Access Compliance Report

Public Rights-of-Way

Intersection ID: 49930	Main Street: PAXTON_RUN_RD	Cross Street: CHAMBERLIN_RD	Location: NW
ADA ID: DA224D8FFB8E	Ramp Type: PerpDiag	Initial Pass/Fail: Fail	Overall Compliance: No
Severity Score: 1.25			
Codes/Mitigation Info/Possible Solution		Field Measurements/Component Compliance

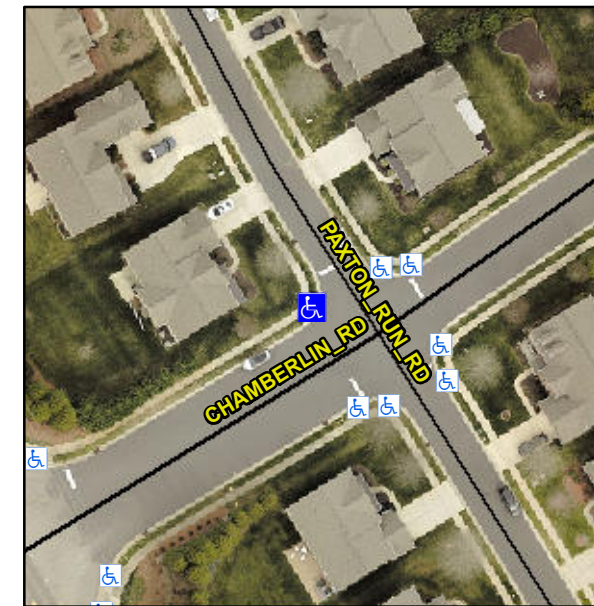
Not Found, R304.5.3

Compliance	Description	Data	Compliance	Description	Data
N/A	Ramp Length (in)	48.0	Yes	Ramp Slope (%)	8.0
Yes	Ramp Width (in)	48.0	No	Ramp XSlope (%)	2.5
N/A	Flare Type LT	N/A	N/A	Flare Type RT	N/A
N/A	Flare Slope LT (%)	N/A	N/A	Flare Slope RT (%)	N/A
N/A	Flare Traversable LT?	N/A	N/A	Flare Traversable RT?	N/A
N/A	Landing Length (in)	N/A	N/A	DWS Provided?	N/A
N/A	Landing Width (in)	N/A	N/A	DWS Contrast?	N/A
N/A	Landing Slope (%)	N/A	N/A	DWS Length (in)	N/A
N/A	Landing X Slope (%)	N/A	N/A	DWS Full Width?	N/A
N/A	Landing Curb? (Y/N)	N/A	N/A	DWS Offset (in)	N/A
N/A	Shared Landing?	N/A			
N/A	Gutter Ponding?	N/A	N/A	Gutter Slope (%)	N/A
N/A	Gutter Lip Ht (in)	N/A	N/A	Gutter X Slope (%)	N/A
N/A	Painted X Walk1?	No	N/A	Painted X Walk2?	No
	X Walk 1 Direction	To SE		X Walk 2 Direction	To NE
N/A	X Walk 1 Width (in)	N/A	N/A	X Walk 2 Width (in)	N/A
	X Walk 1 Slope (%)	2.8		X Walk 2 Slope (%)	4.6
	X Walk 1 X Slope (%)	3.2		X Walk 2 X Slope (%)	1.3

Remove & Replace Curb Ramp With Two New Directional Ramps or Equivalent.
